REVISION: OVERSIGHT CONCERN - DATED FEBRUARY 23RD, 2022
SHEETS: A102, A103, A105, A200, A201, A203, A204, A300, A4.03

NO.	DESCRIPTION	DATE
1	REVISED AS PER CITY COMMENTS - DP	2021-10-27
2	OVERSIGHT COMMENTS	2022-02-23

364 E 14TH STREET
DUPLEX INFILL
COVER SHEET

DATE 01/25/2022

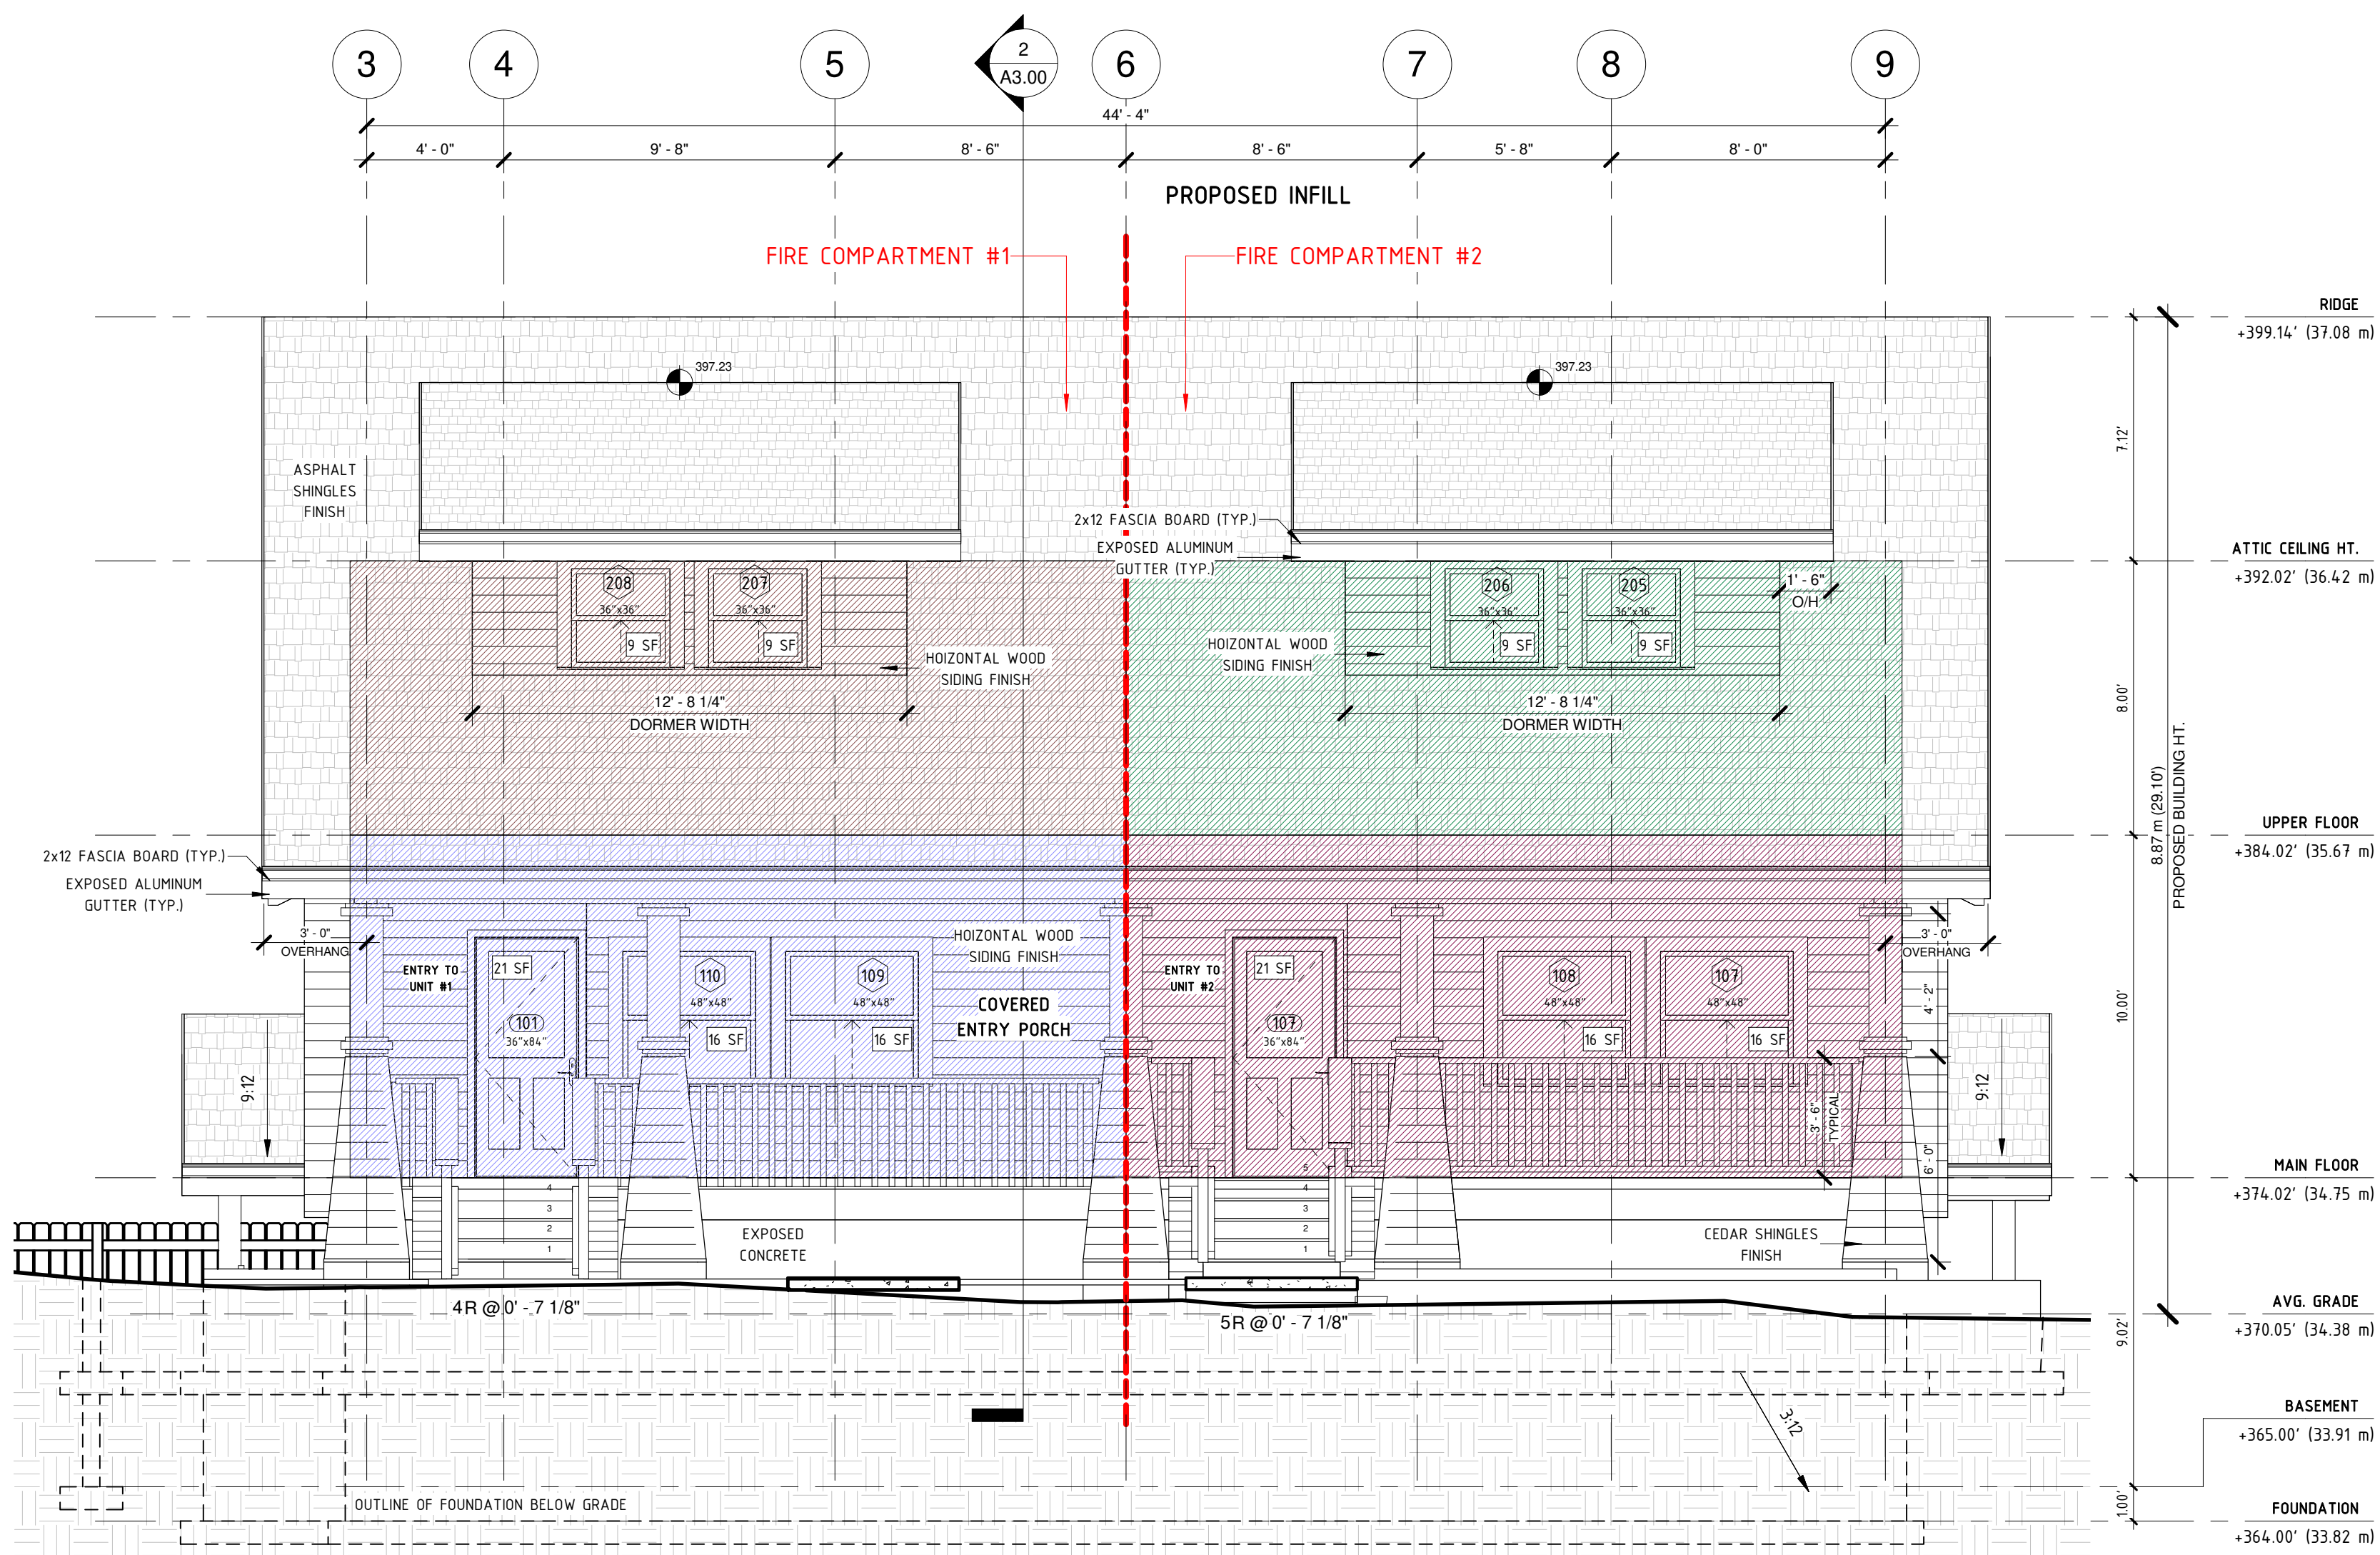
REVISIONS
SPATIAL SEPARATIONS CALCULATIONS UPDATED AS PER LAYOUT CHANGES

DUPLEX INFILL
INFILL- E & N ELEVATIONS (LDC)

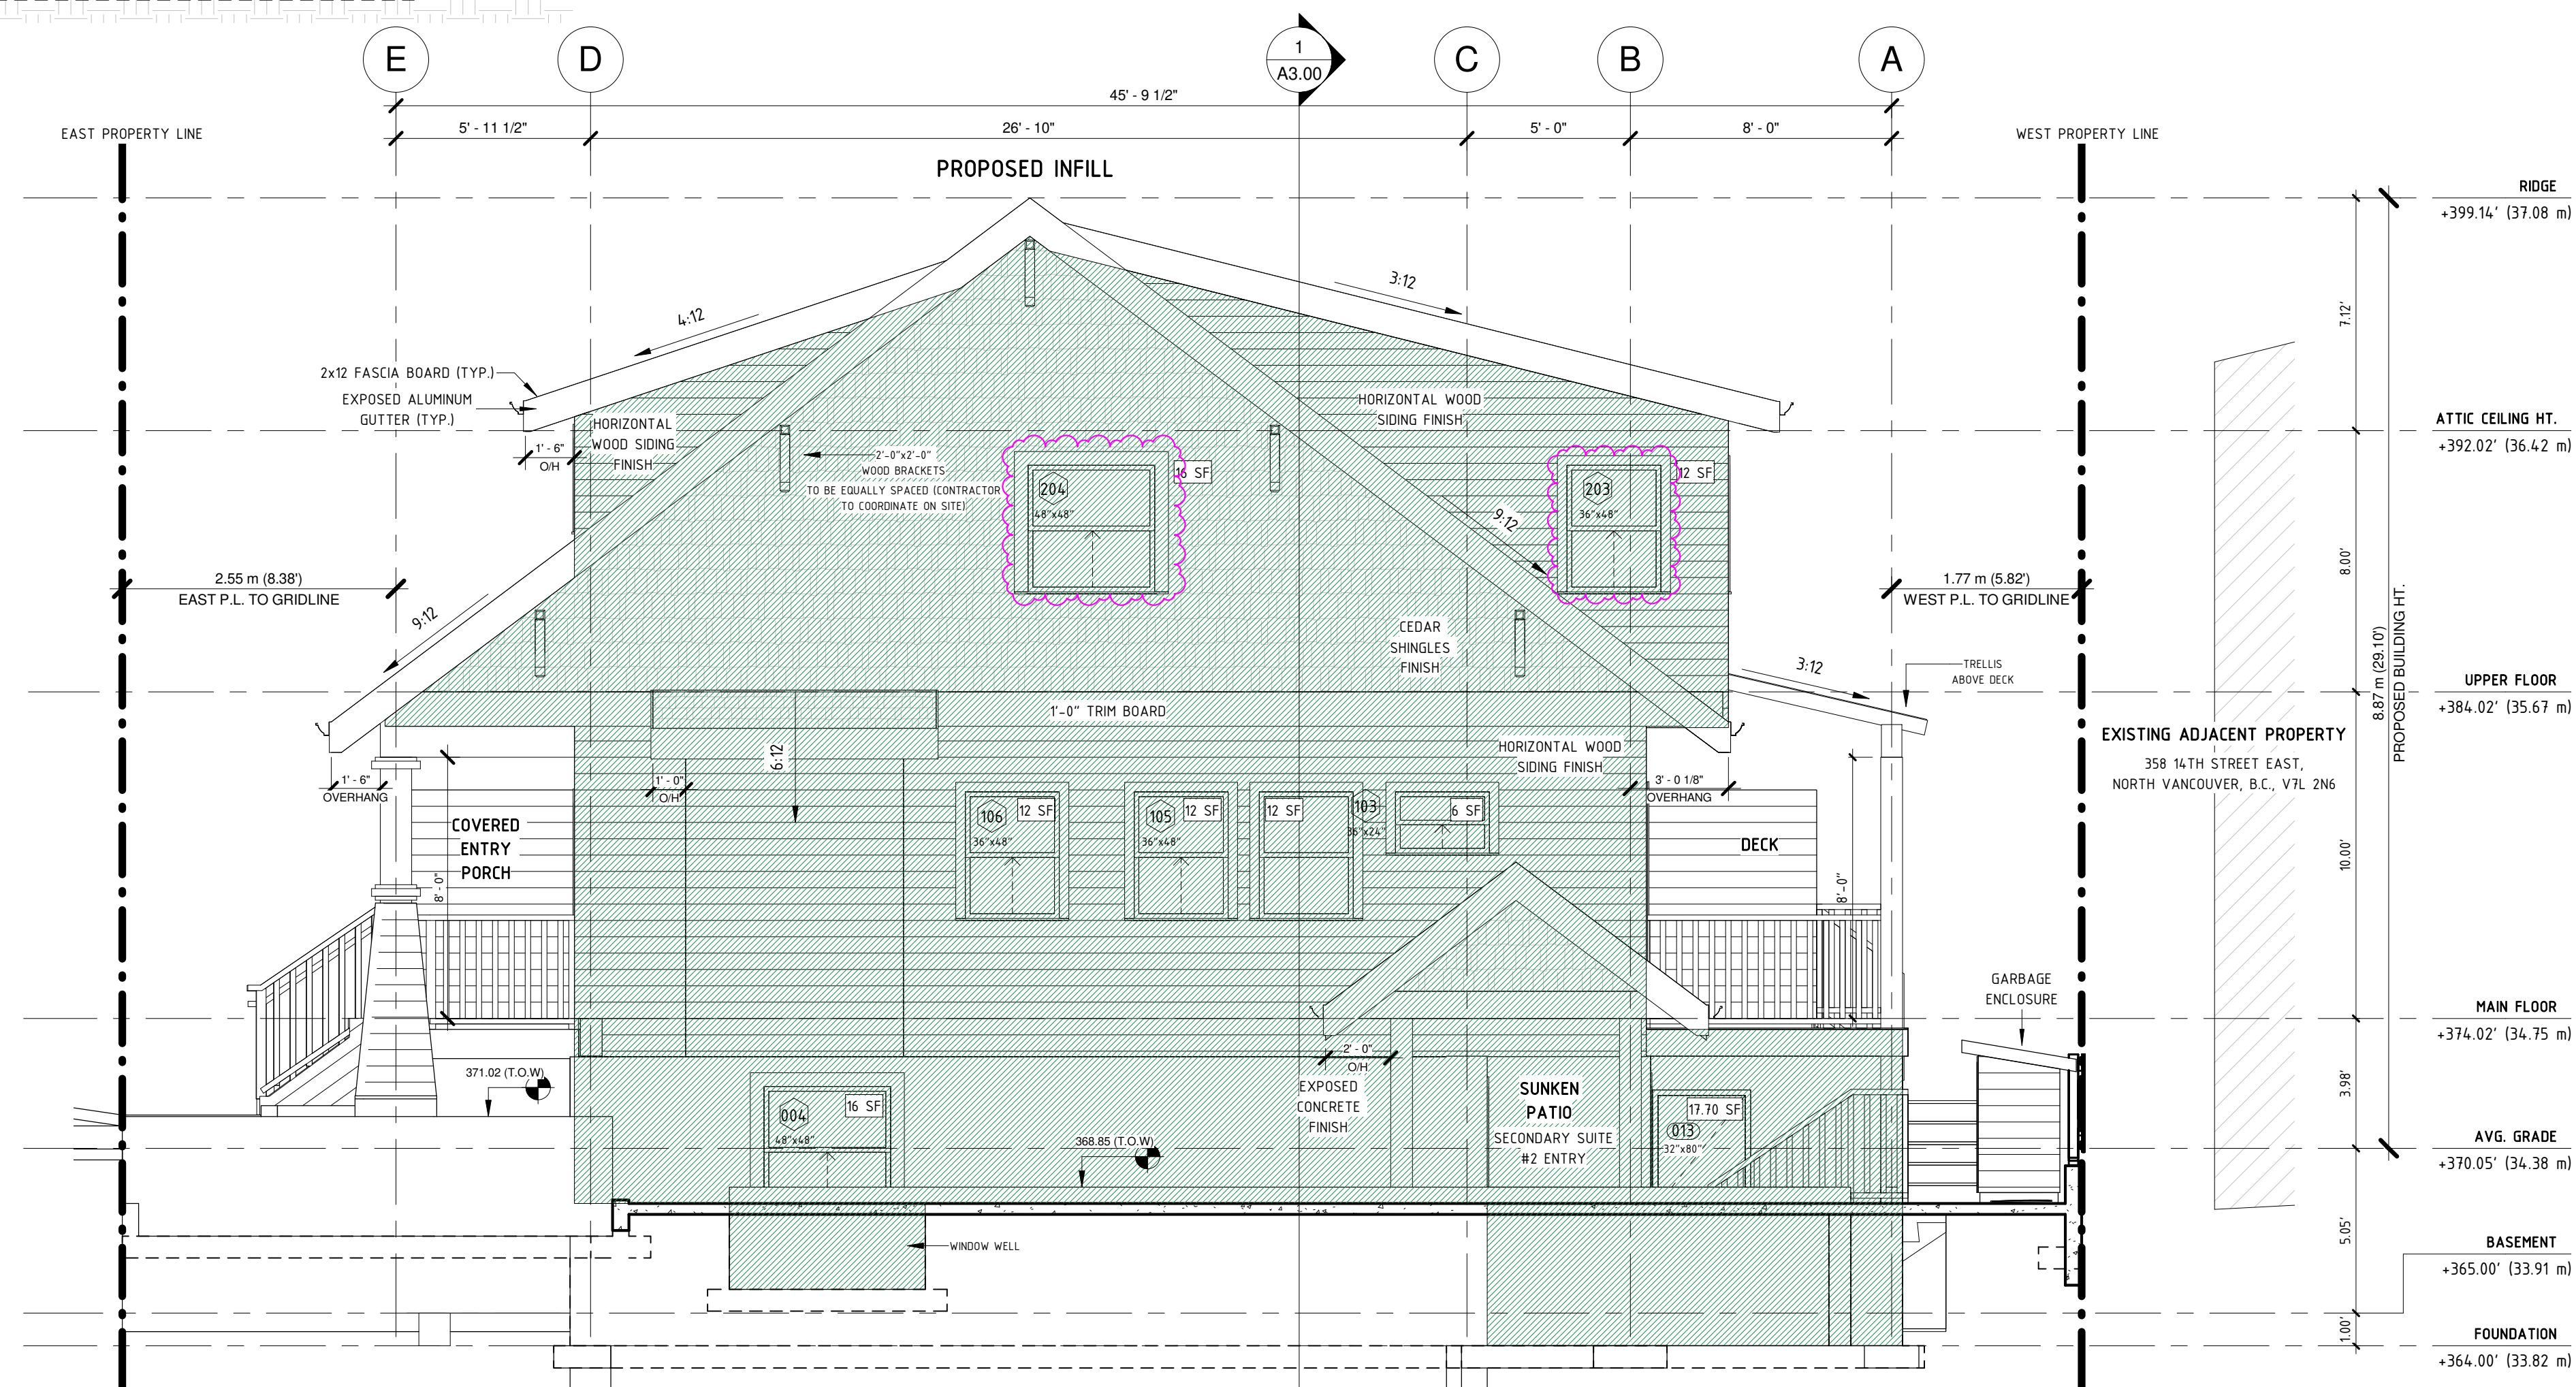
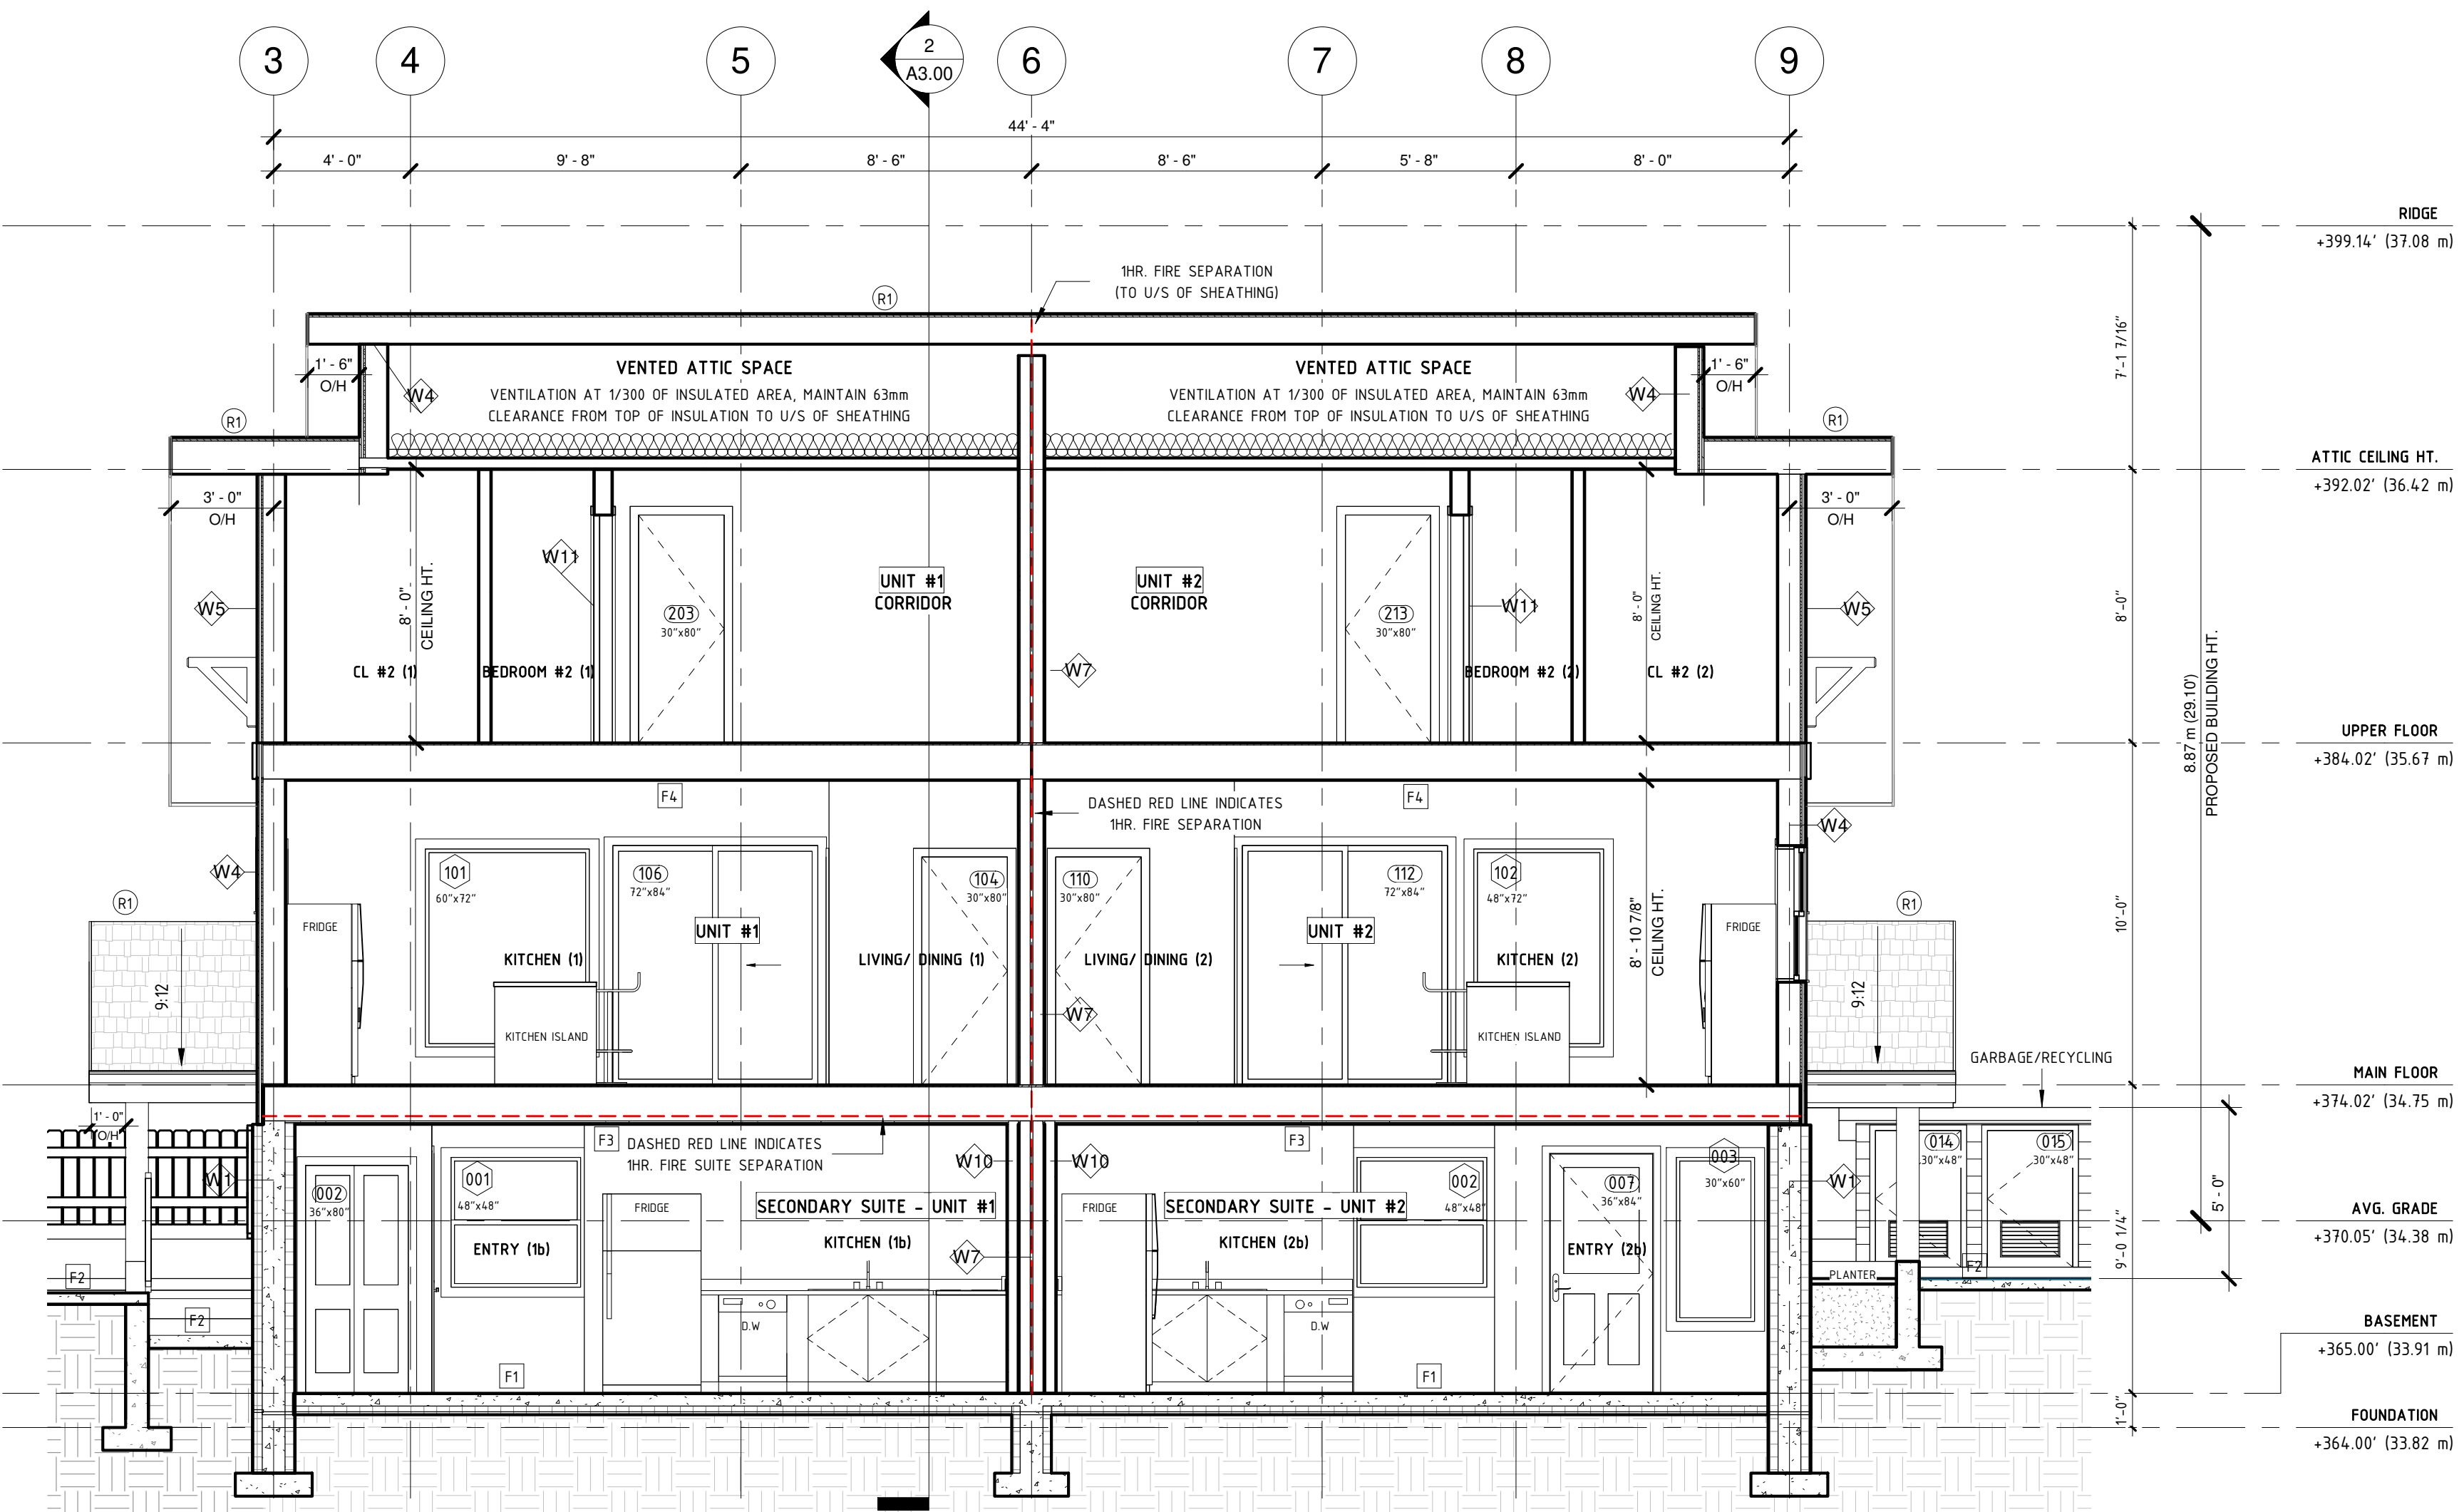
REVISIONS:
1 SPATIAL SEPARATIONS CALCULATIONS UPDATED AS PER LAYOUT CHANGES
